Subject: Request for Revision of National Pollutant Discharge Elimination System  
(NPDES) Permit No. IL0005037

Subject: Request for Revision of Quad Cities Station NPDES Permit  
NPDES Permit No. IL0005037

**REVISED TEMPERATURE MONITORING CURVE FOR  
QUAD CITIES NUCLEAR GENERATING STATION**

Figure 1. Existing Temperature Monitoring Curve.

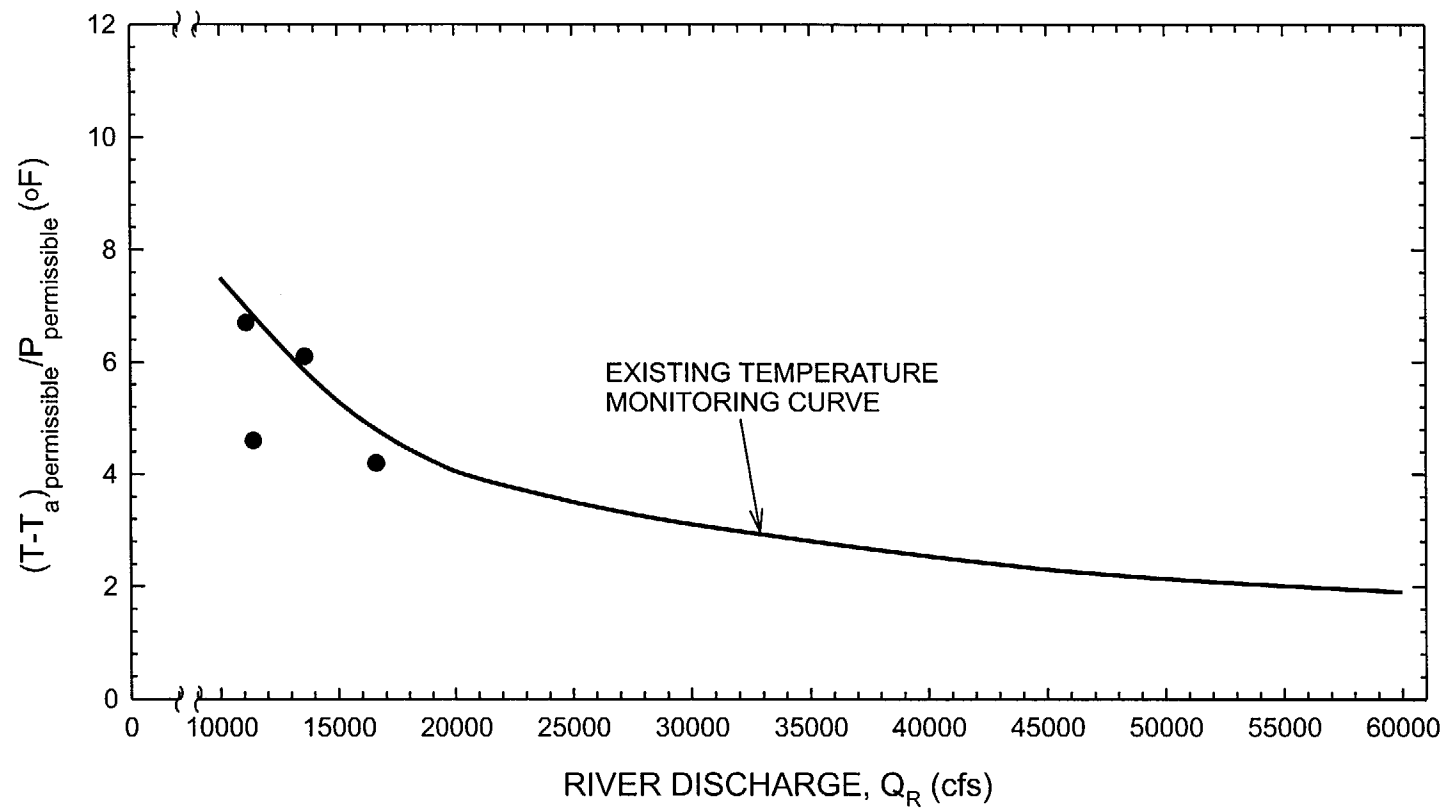
The existing TMC, presented in Figure 1, was developed by modifying the old TMC (Commonwealth Edison, 1981) with the use of the QCNGS thermal-plume data collected by Iowa Institute of Hydraulic Research (IIHR) during the drought of 1988 and 1989. The method for the development of the existing TMC is included in a report by Jain and Kennedy (1990). The field data that were utilized in developing the existing TMC are presented in Table 1 that also includes the maximum excess temperature observed,  $(T-T_a)_{\max \text{ obs}}$ , at a river cross-section 500 ft downstream from the diffuser pipe and the corresponding maximum excess temperatures estimated at full load,  $(T-T_a)_{\max \text{ full}}$ , where  $T$  = water temperature and  $T_a$  = ambient water temperature. The maximum excess temperatures at full load were estimated under the assumption that the local excess temperatures are directly proportional to the fractional plant load,  $P$ , defined as

The main assumption in the development of the existing TMC is that the local excess temperatures are directly proportional to the plant load. This assumption is valid only if complete mixing of the river flow and diffuser effluent is achieved. Using a one-dimensional analytical model, a parameter  $R$ , termed discharge ratio, was identified to ascertain the degree of mixing of the ambient flow with the effluent (Jain and Kennedy, 1990). The discharge ratio is defined as the ratio of the ambient flow discharge to the diffuser discharge. The smaller is the discharge ratio, the more intense is the mixing of the ambient flow with the effluent. The discharge ratio decreases with increasing diffuser discharge. Because the diffuser discharge is larger for the revised TMC than the existing TMC, the assumption of complete mixing is valid. It should be mentioned that though complete overall mixing in the field was complete, but it was not uniform. There were local “hot and cold spots”. The reason for hot spots is the relative deficiency of dilution water supplied by the ambient flow in the region of hot spots.

Figure 2. Revised Temperature Monitoring Curve.

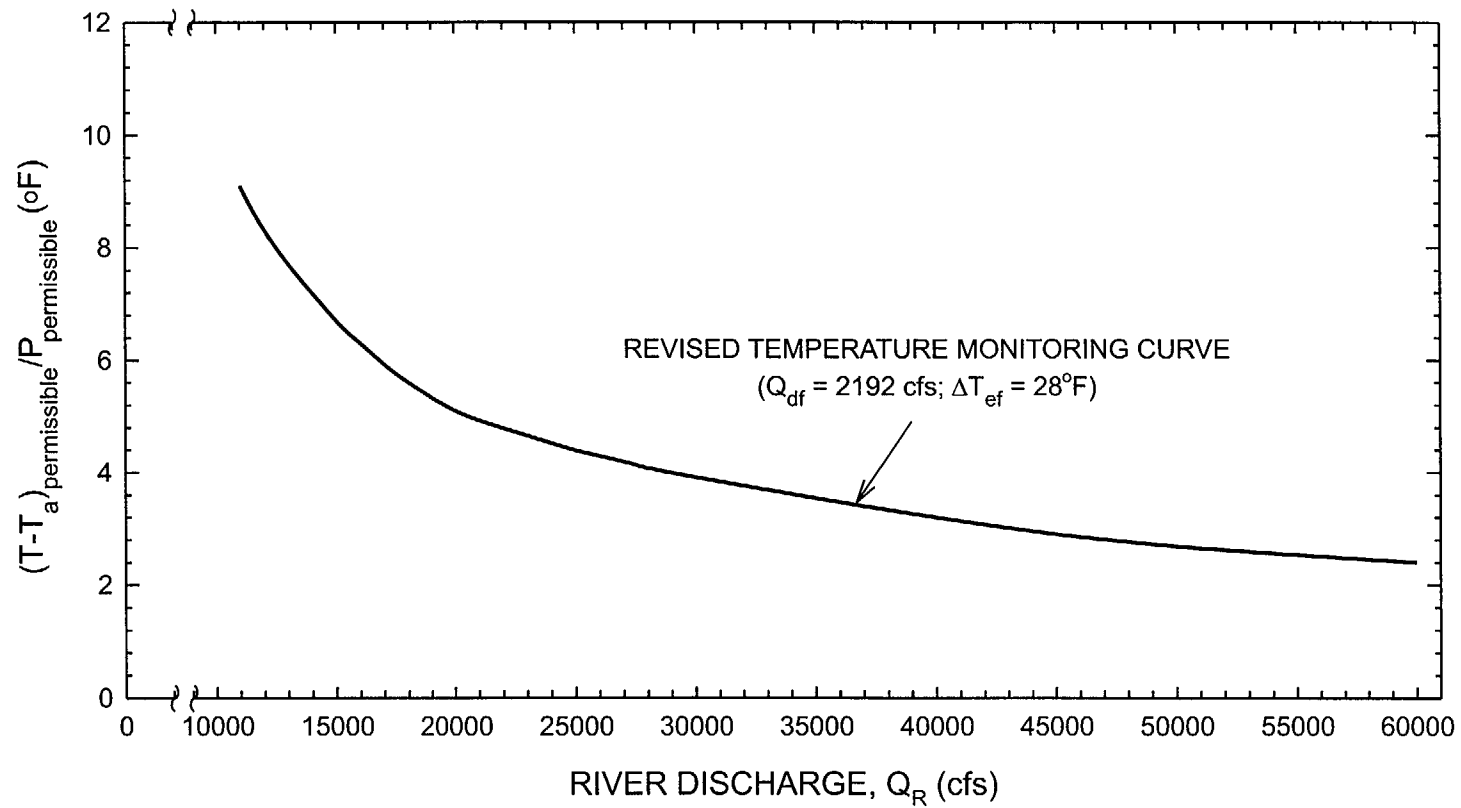
In connection with the EPU project, Exelon retained Dr. Subhash C. Jain to revise the temperature monitoring curve to reflect an increase in the discharge temperature of 5.0°F. Dr. Jain was one of the principle investigators responsible for conducting the 1990 study

that established the temperature monitoring curve referenced in the current permit. The report "Revised Temperature Monitoring Curve for Quad Cities Nuclear Generating Station" is enclosed for your review. The revised temperature monitoring curve indicates that at river flows of 21,100 cfs and greater, sufficient mixing is observed in the river to conclude that at any power level, the plant will not cause exceedence of the permitted thermal limits. Exelon proposes the Agency revise the permit to reflect this value and change Footnote 1 to reflect the revised temperature monitoring curve.

The existing TMC can be modified for applicable to the revised maximum effluent discharge and excess temperature by multiplying its ordinates by the ratio  $\alpha = 1.27$ . The revised TMC is presented in Figure 2.

1. When river flow is 21,100 cfs or greater and ambient river temperature is 5°F or more lower than the monthly limiting temperatures, the temperature monitoring curve<sup>1</sup> establishes that the Permittee is in compliance for all power generation levels;
2. When river flow is less than 21,100 cfs and/or ambient river temperature is within 5°F of the monthly limiting temperatures, the Permittee shall demonstrate compliance using either:
  - (a) Plant load, river flow, ambient river temperature, and the temperature monitoring curve, or
  - (b) Field measurement<sup>2</sup> of the river cross-sectional average temperature taken 500 feet downstream of the diffusers.

<sup>1</sup>The revised temperature monitoring curve identified as Figure 2 in the December 2000 "Revised Temperature Monitoring Curve for Quad Cities Nuclear Generating Station."
